Memorandum

Re: **Item #21 Aura (f.k.a. 5 Park) – 16955-17071 West Dixie Highway**

**Response to Technical Review of Applications for Development (TRAD) comments
dated March 25, 2021**

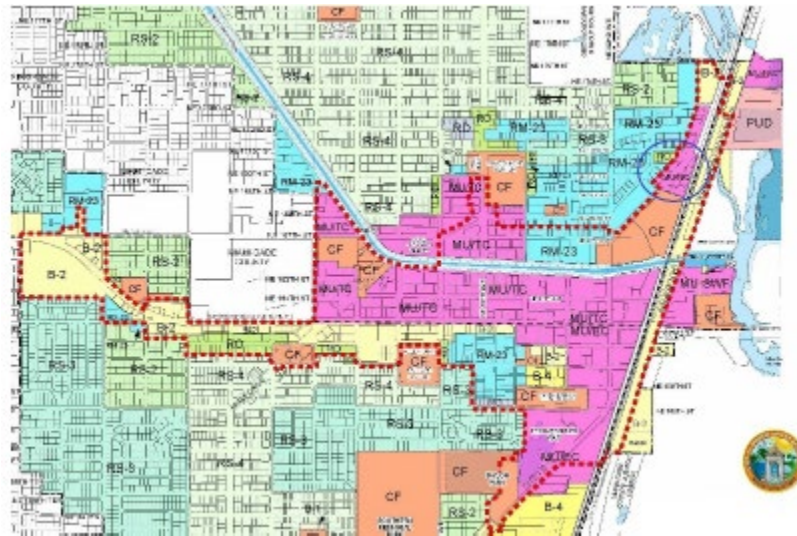
1. Please update the traffic report to identify that the project site is within the City of North Miami Beach CRA boundaries. The traffic study should include a narrative regarding meeting the traffic concurrency exemption requirements as outlined in the City Code of Ordinances.

Response: As indicated by the CRA map provided, this project is found to be within the Community Redevelopment Agency (CRA) area. However, since this project was previously approved and it meets all the Level of Service requirements, the applicant is not interested in being exempt from Traffic Concurrency.

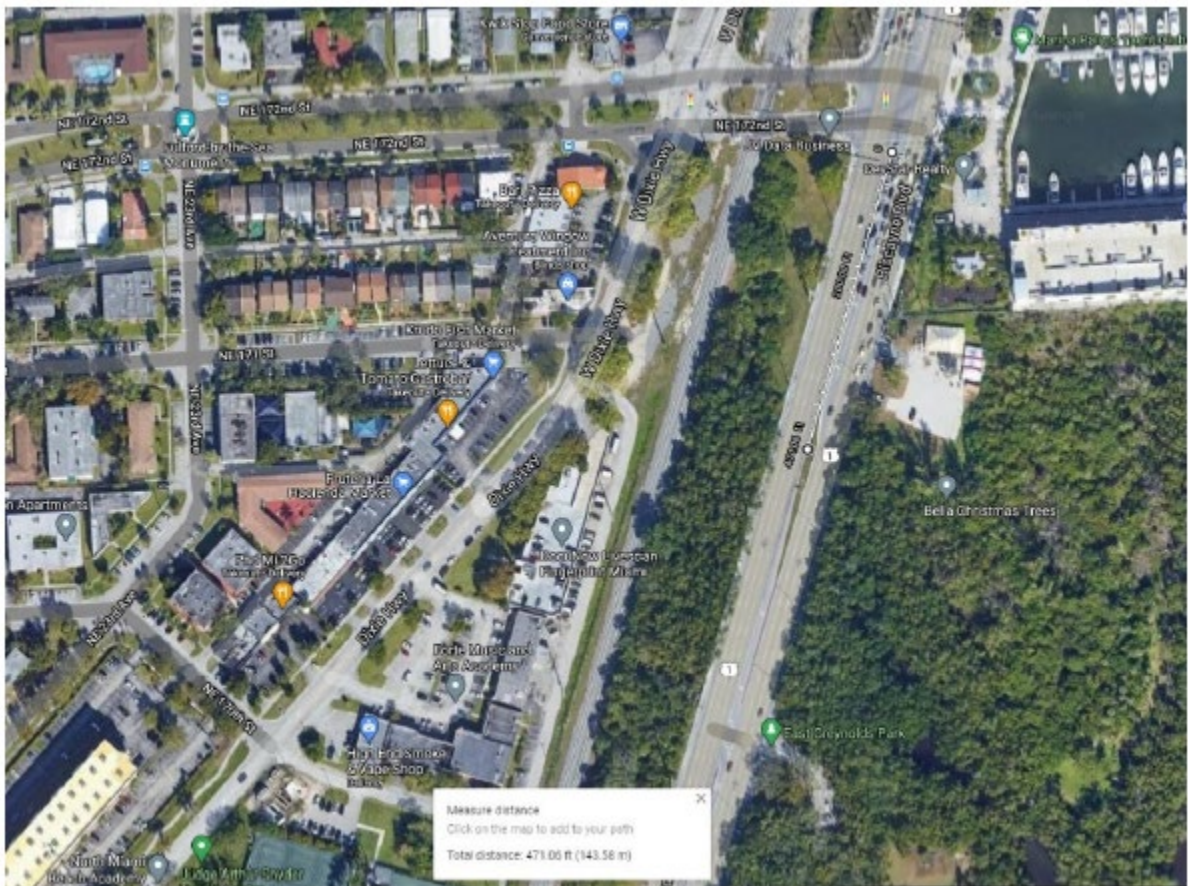
3. Projects that have direct or immediate access to West Dixie Highway shall be subject to the review and approval by FDOT and/or Miami Dade County Department of Transportation and Public Works (DTPW) for compliance with FDOT and Miami Dade County standards. Please provide an approval letter from FDOT and/or Miami Dade County as part of your resubmittal for the improvements to the driveway connection along W Dixie Highway.

Response: We will provide approval letters once received.

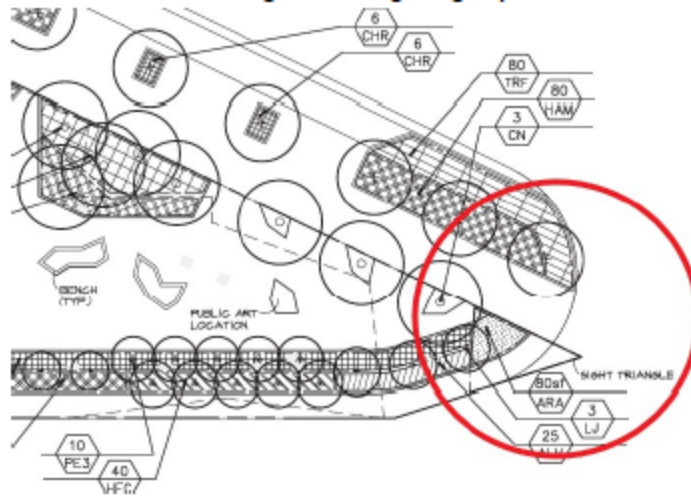
- Please provide details regarding mitigation improvements for the intersection of West Dixie Highway and 172nd Street signalized intersection. The future with project total traffic

conditions in the PM peak hour confirm that the 95th percentile vehicle queue of 231 LF for the westbound through movement extends into the existing adjacent signalized intersection of US-1/Biscayne Boulevard and US-1. Please address this traffic operational concern at this intersection location in the narrative of the traffic impact study.

Response: The westbound movement of West Dixie Highway and NE 172nd Street is constrained by the railroad crossing (FEC jurisdiction), Biscayne Blvd (FDOT jurisdiction) and also falls under the purview of Miami-Dade County. It is the responsibility of these agencies to address any deficiencies. However, since this intersection is currently under design for the widening on West Dixie Highway, these agencies will be reviewing and making any necessary improvements.

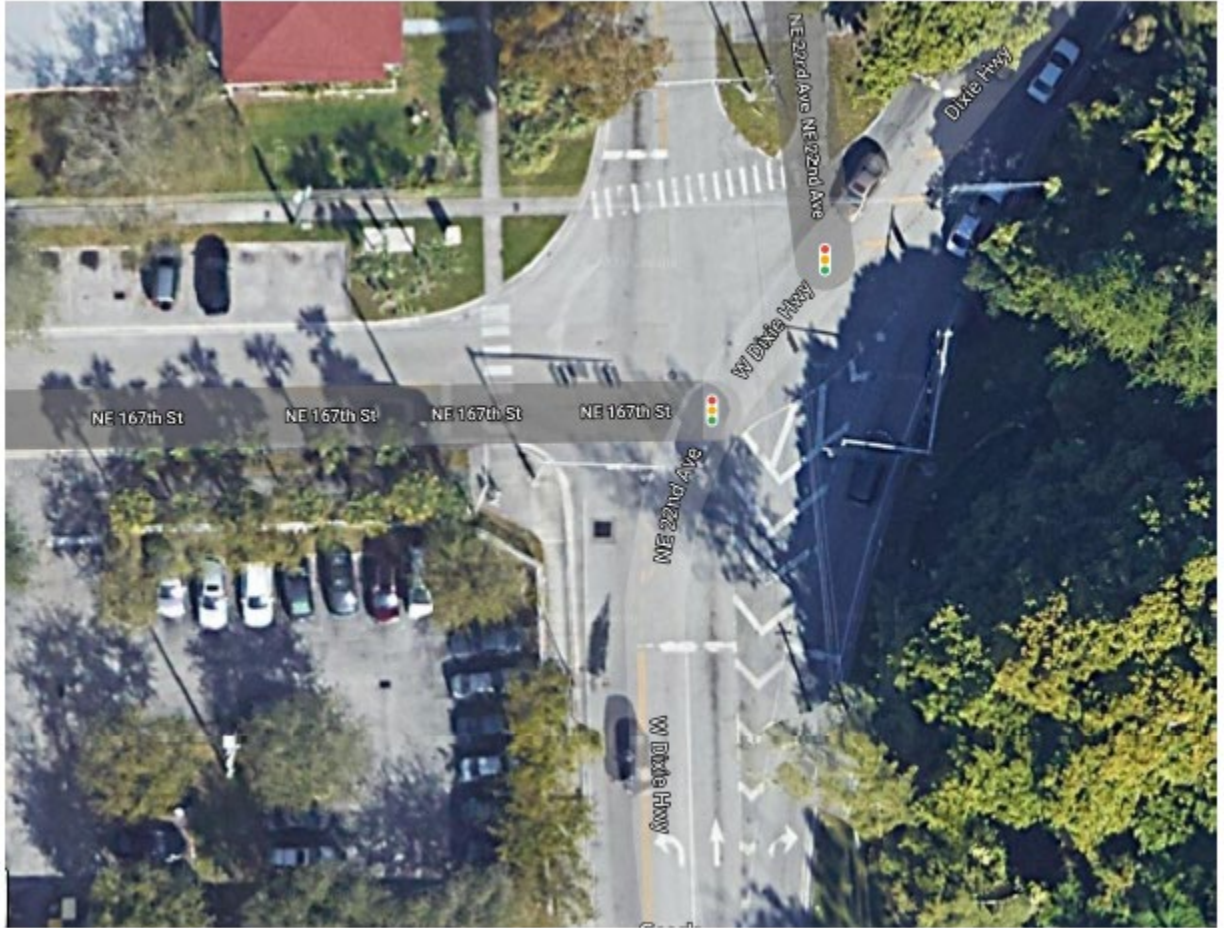
9. Please provide more specific details of the program date for the completion of the West Dixie Highway Improvement project mentioned in the Planned Improvements section. This should include confirmation if the proposed improvements will be completed by the projected build-out date. This should include specific reference to any additional improvements that have been included as geometric modifications in the modeling of relevant intersections. This includes the existing signalized intersection of West Dixie Highway and NE 167th Street/NE 22nd Avenue. This intersection includes dual northbound right turn lanes and two lanes for the southwest movement which are not present in the existing conditions.

Response: The improvements to West Dixie Highway have been done by Miami-Dade County for the City of North Miami Beach. This roadway widening is currently at the 90 percent design phase and design should be completed within the next few months. It is our understanding the City is looking to begin construction immediately; however, we have not been provided specific dates. Further, we believe the City may have more detailed information on the progress of this project.

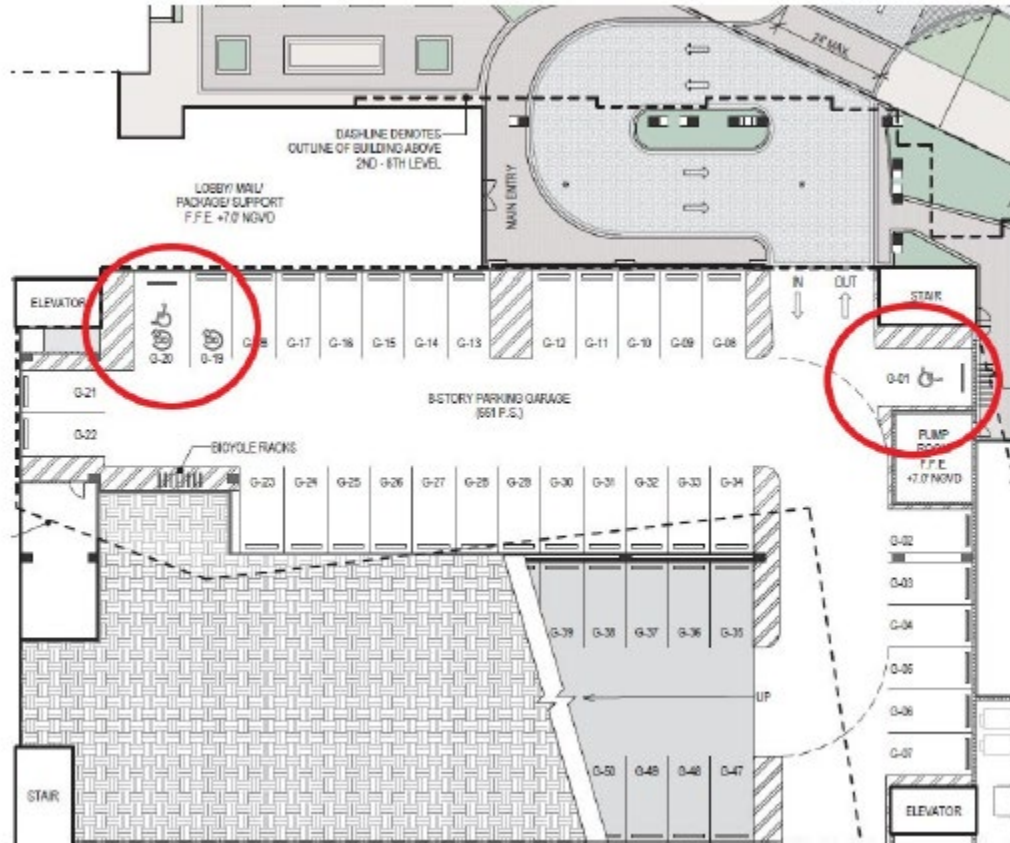
11. Please ensure that the handicap parking spaces are oriented appropriately on all plan sheets per the Miami Dade County and North Miami Beach handicap accessible parking space details and criteria. This comment applies to all ADA spaces on all parking garage levels. The standard parking space dimensions should be a minimum of 9' wide x 18' long per Section 24-93 of the Code of Ordinances. The handicap parking space dimensions should be a minimum of 12' wide x 20' long per Section 24-93 of the Code of Ordinances.

Response: Please refer to latest sheets SP-1, and A.202 to A-2.05 for revised ADA spaces markings. Typical dimensions for ADA spaces have also been added for clarification.

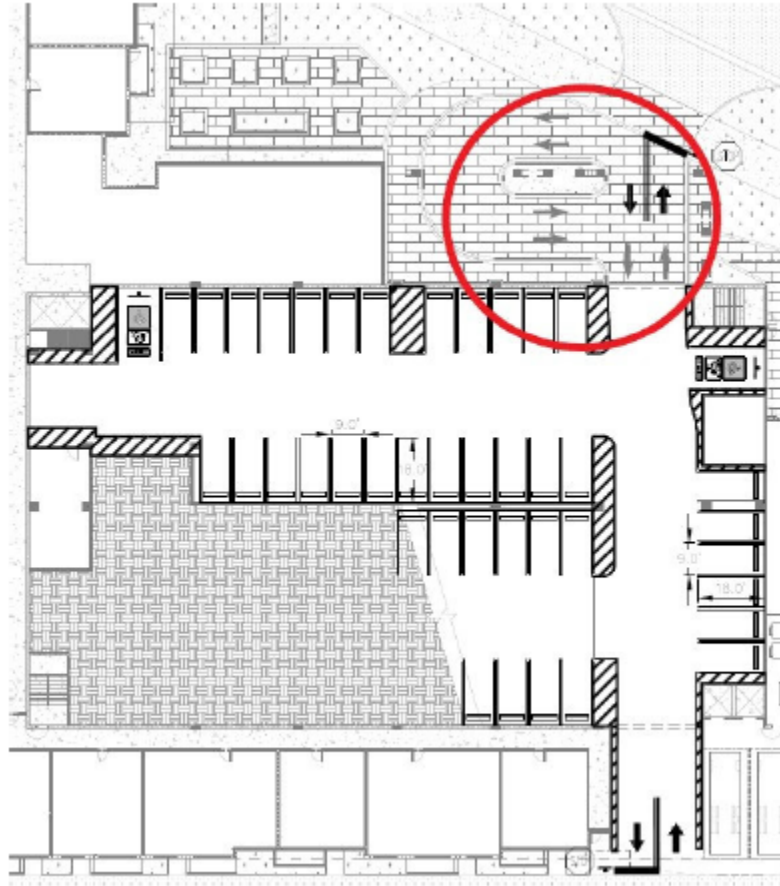
12. Please provide additional stop control at the intersection of the garage and the circular drop off pick up area. This should include consideration of the placement of One-Way and Do Not Enter signs per MUTCD at the intersection of the garage and circular drop off pick up area.

Response: Please see the Pavement Marking & Signage Plans.

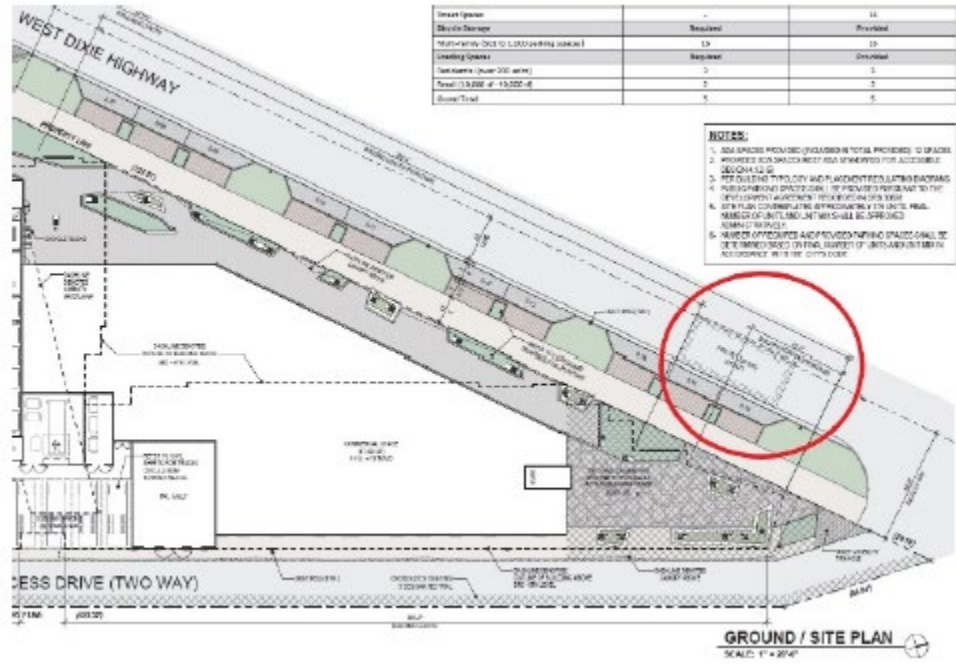
13. Please provide Fire Rescue approval for the proposed set-up areas. The set-up areas within West Dixie Highway are near the 171st Street intersection and one location is on a horizontal curve.

Response: We will provide approval once received.
